Change Order

Project Name: LC Government Center Courthouse FCI #: 50-17-006

CO# 011

COR #019: Expose Exterior Window @ Rm 2107 (MM Item 036-002)	\$7,421.00
COR #020: Data Outlets @ Rm. 2116, 3213, & Work Station	\$2,978.00
COR #022: Exit Signs in Penthouse (MM 038-003)	\$1,294.00
COR #023: Upgrade damaged 3 data ports in License (MM 035-001)	\$407.00
COR #025: Added Door in AHU #001 & 002 (MM 037-001)	\$17,762.00
<b>TOTAL</b>	<b>\$29,862.00</b>

Laramie County Courthouse Remodel  
Cheyenne, WY  
FCI Constructors of Wyoming  
50-17-006

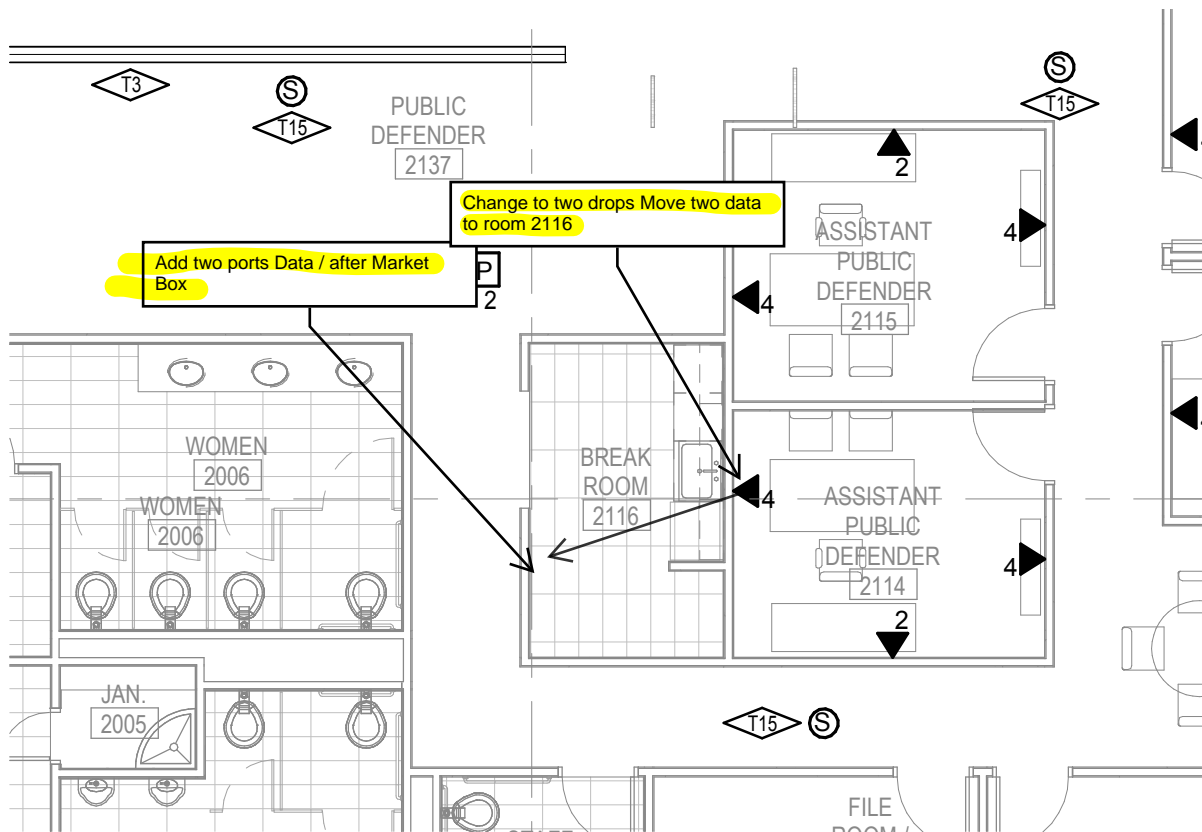
Going back to our 2/28 conversation regarding moving 2 each tele-data outlets to Rm 2116, can you please review the attached and let me know if this is correct and I will send out to the subs.

Ridge Electric - Cut in new single j-box for 2 - each tele-data outlets. Final location to be located anywhere (convenient) along (plan) west wall in Rm. 2116 - Break Room. Also includes rough-in necessary.

Team Linx - Move 2 each tele-data outlets (already installed) in Rm. 2114 - Assistant Public Defenders to Rm. 2116 - Break Room. Includes modification to existing face plate in Rm 2114 for remaining tele-data outlets and supply/install face plate at new location.

This is correct. We need data for a printer in the break room so that people can keep working during their breaks.

## Request for Information 080

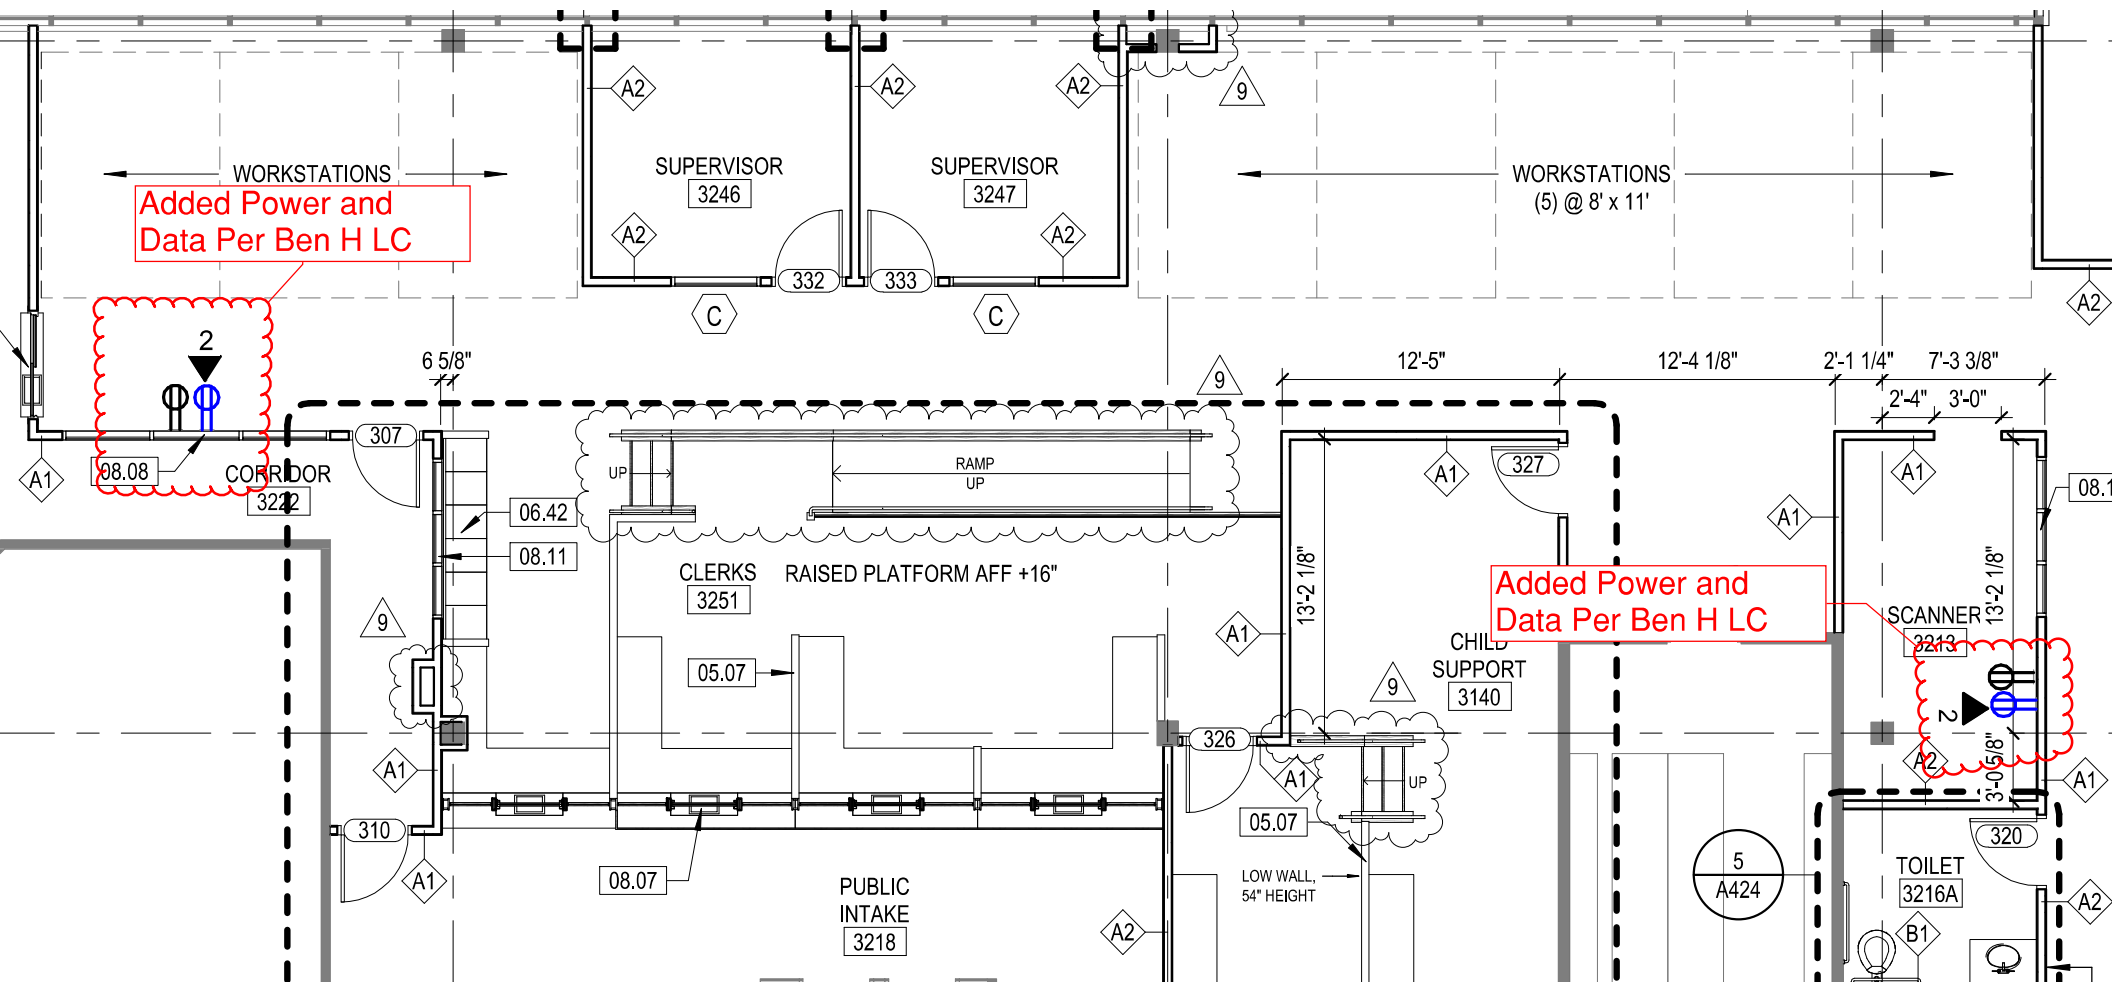
Per Laramie County request to add power and data to 2 location on 3rd floor.

1. Scanner Room 3213

2. Evidence Research Work Stations.

Please advise of what circuit to pull power from.

Scanner Room already has two (2) circuits dedicated for scanners. (PP32-32, 34). If a third scanner is needed, connect to PP32-17. It appears it only feeds general use receptacles in the Scanner Room.

PP32-23 only has 3 receptacles on it currently according to record plans. Extend circuit to new workstation.
